ADDENDUM 01

DATE 02.04.23
 PROJECT NO. 2154
 PROJECT WEST FIELD SR. SEMINARY
 FROM STUDIO 333 ARCHITECTS

This Addendum forms a part of the Contract Documents and modifies the original Bidding Documents dated 01.25.23, as noted below. Acknowledge receipt of this Addendum in the space provided on the Bid Form. Failure to do so may subject the Bidder to disqualification.
This Addendum consists of 2 pages and the attached Drawing Sheets SD1.1, CE1.1, CE2.1, CE3.1, CE4.1, CE5.2, L201, A1.3, A5.1, A5.11, EP101, EP102, EE501, ES101,

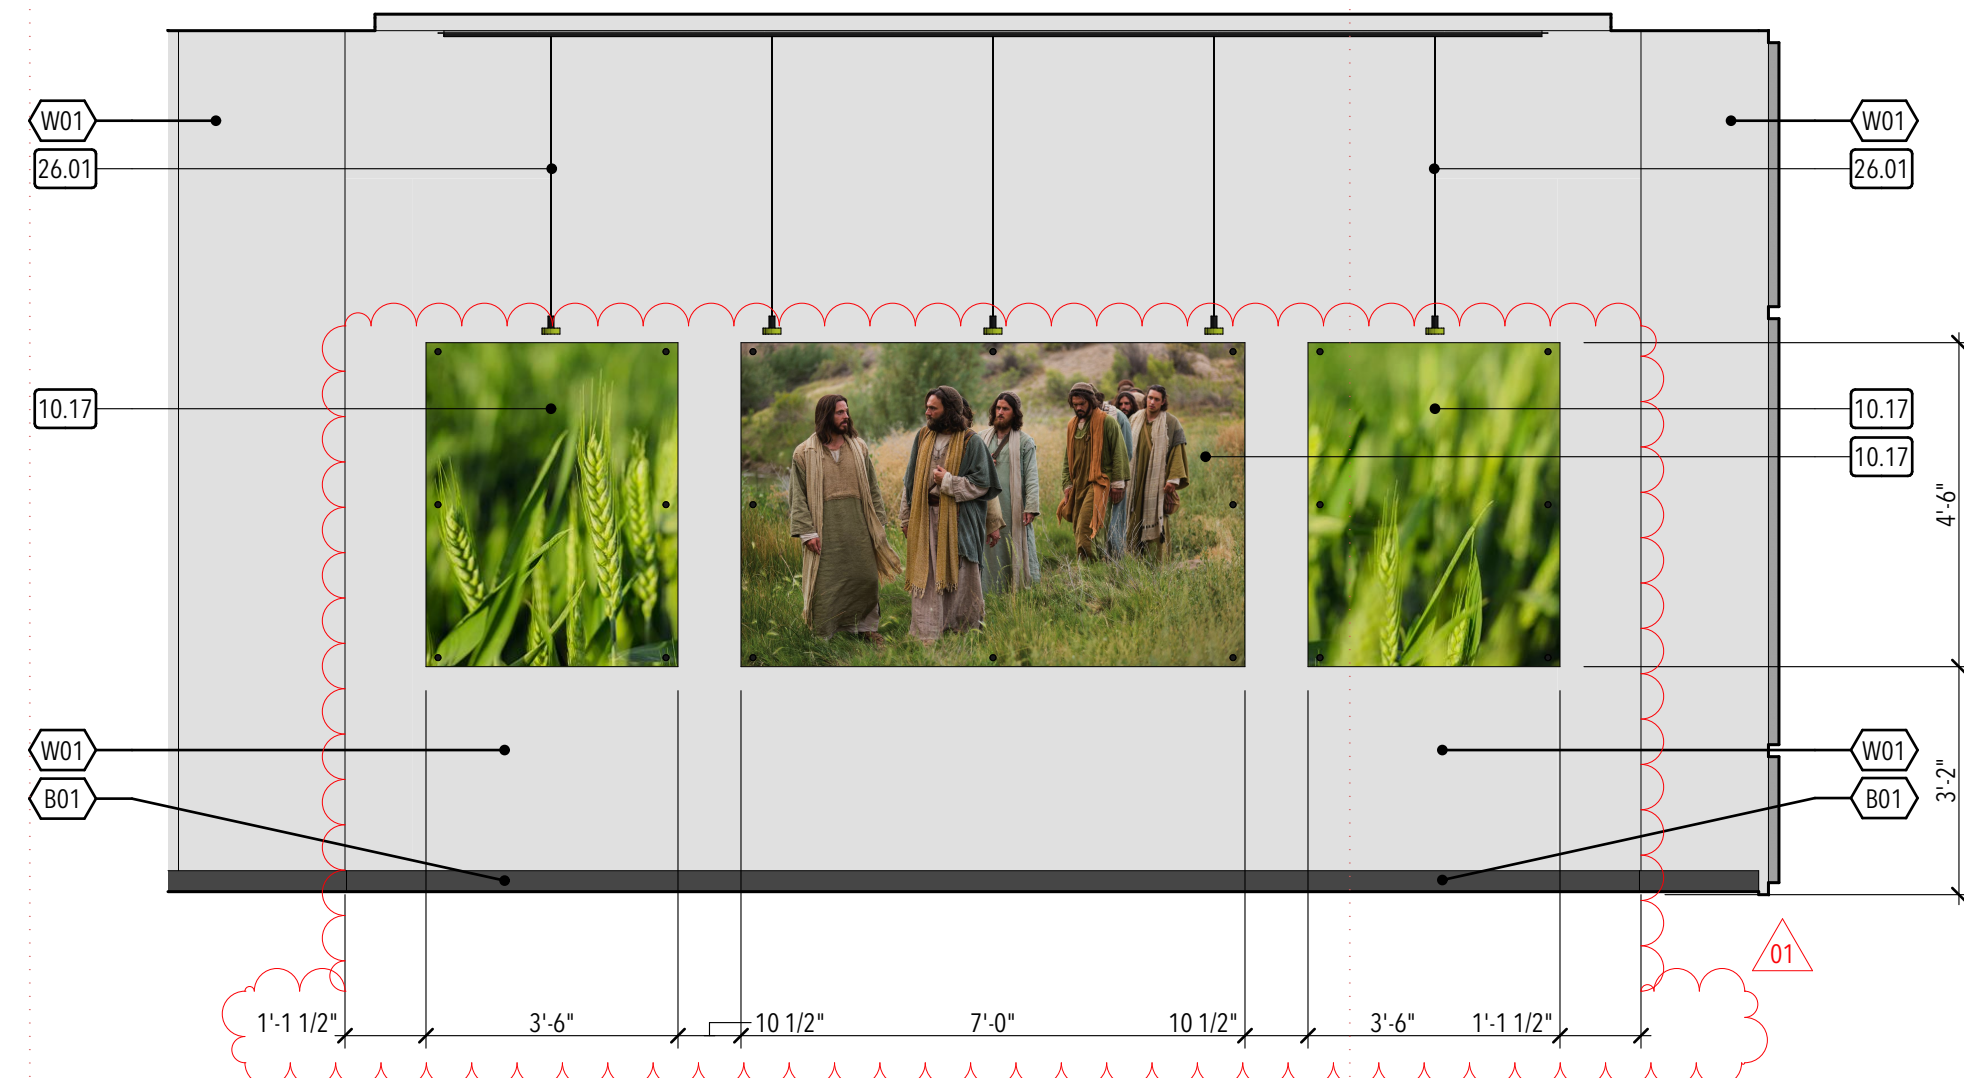
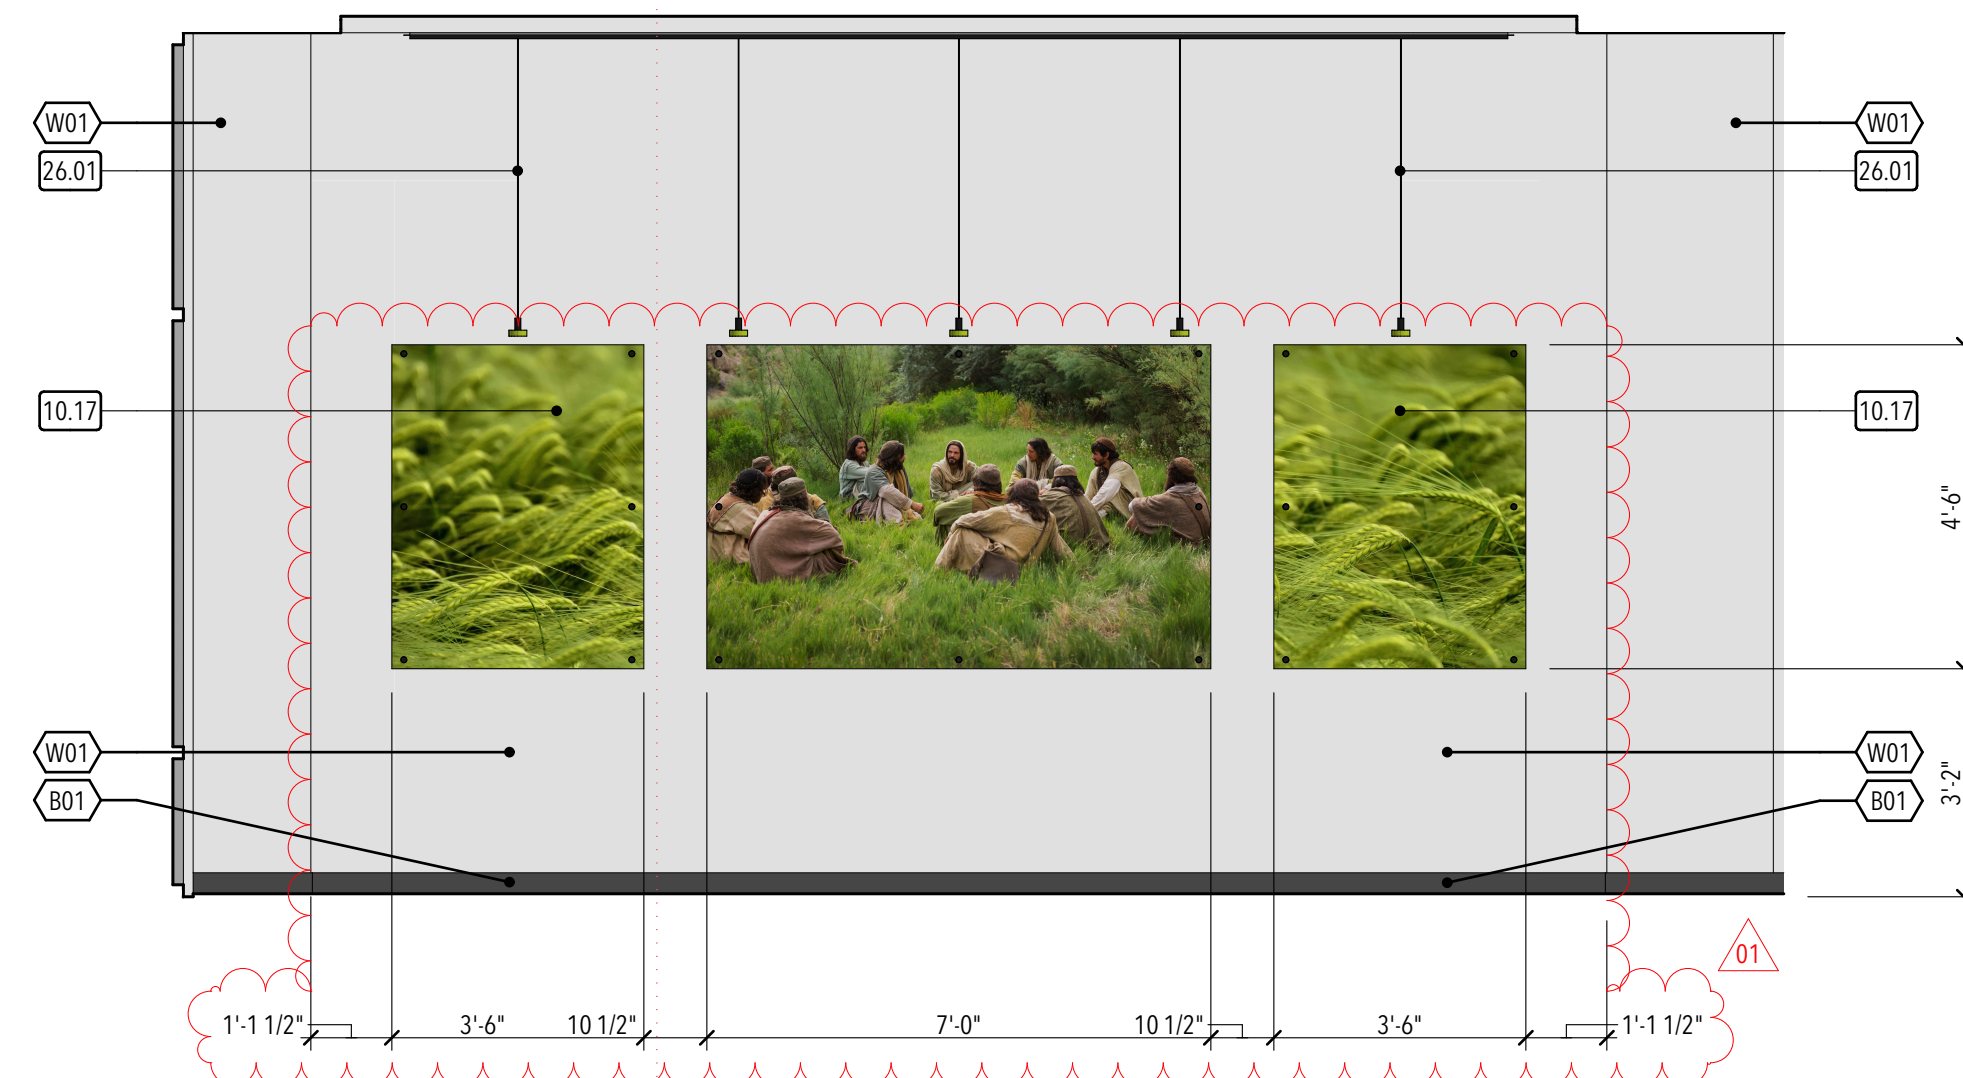
- a. The dimensions and quantities of the acrylic glass printed artwork have been modified on interior elevations 01 and 02/A5.11.
- 11. Sheet EP101-1ST LEVEL POWER PLAN:

1 1ST LEVEL POWER PLAN
SCALE: 1/8" = 1'-0"

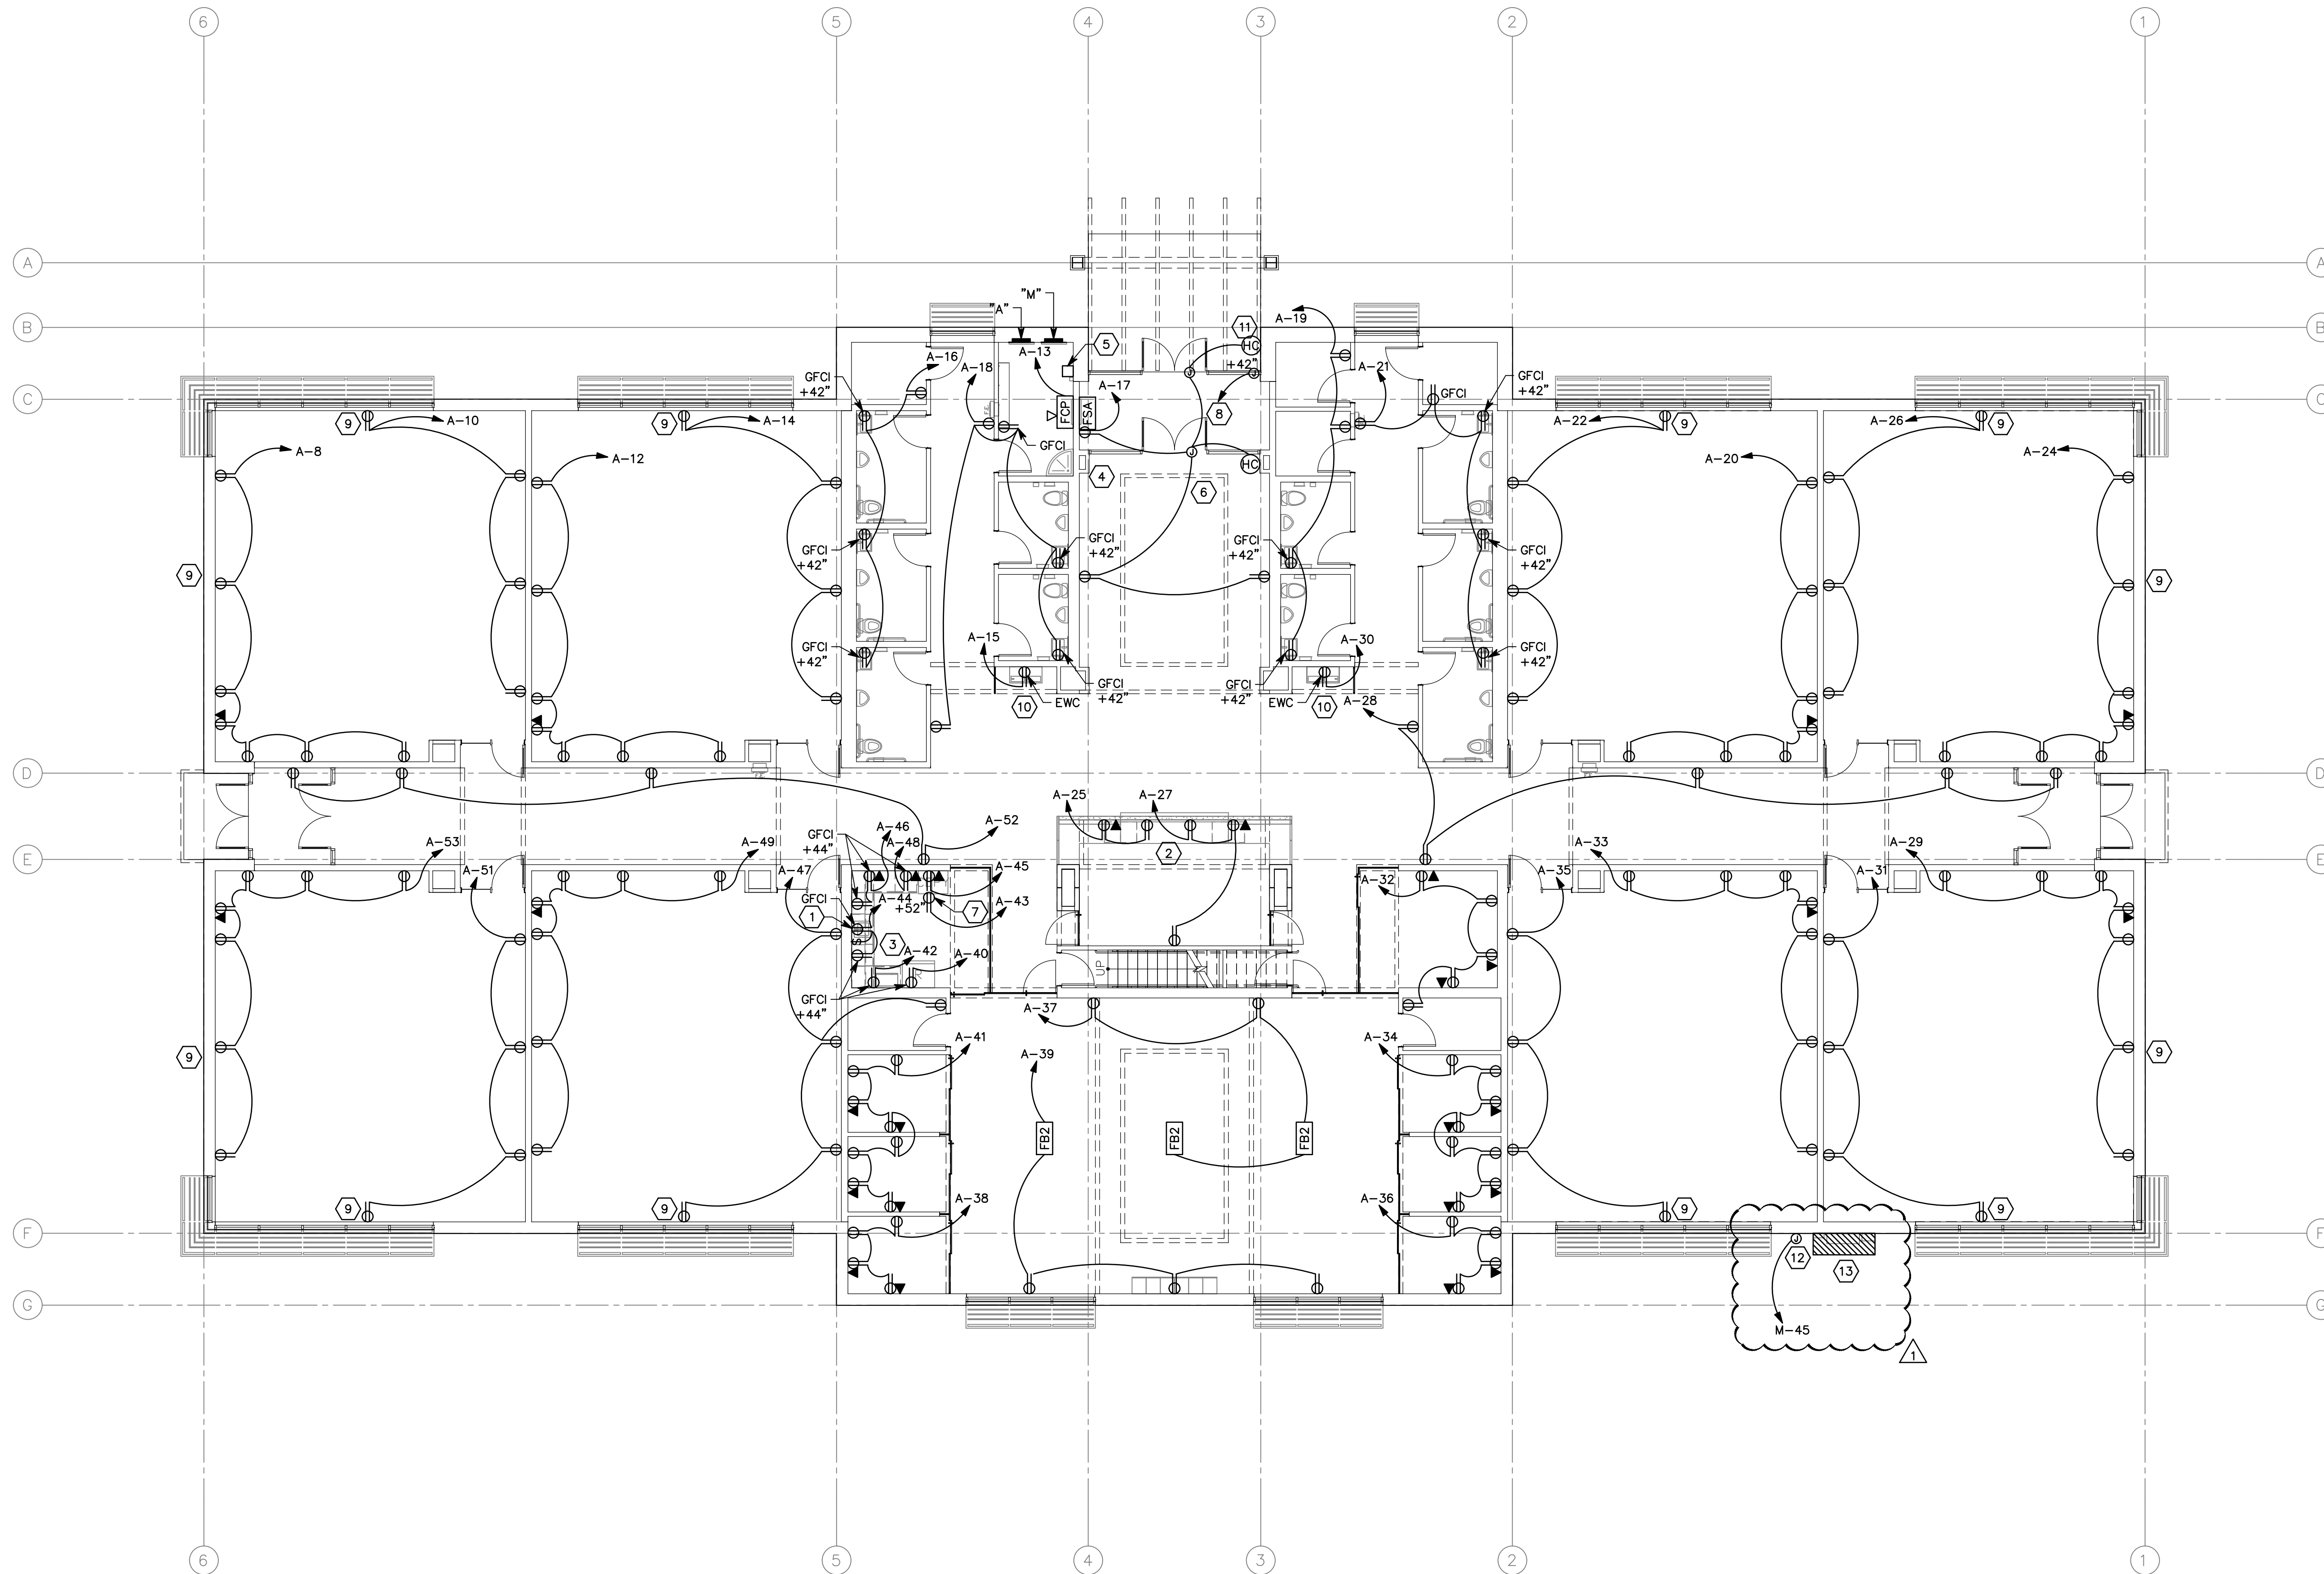
- a. Added circuit for weather track controller on exterior of building adjacent to electrical equipment (MDP, meter/CT)
- 12. Sheet EP102 - 2ND LEVEL POWER PLAN:
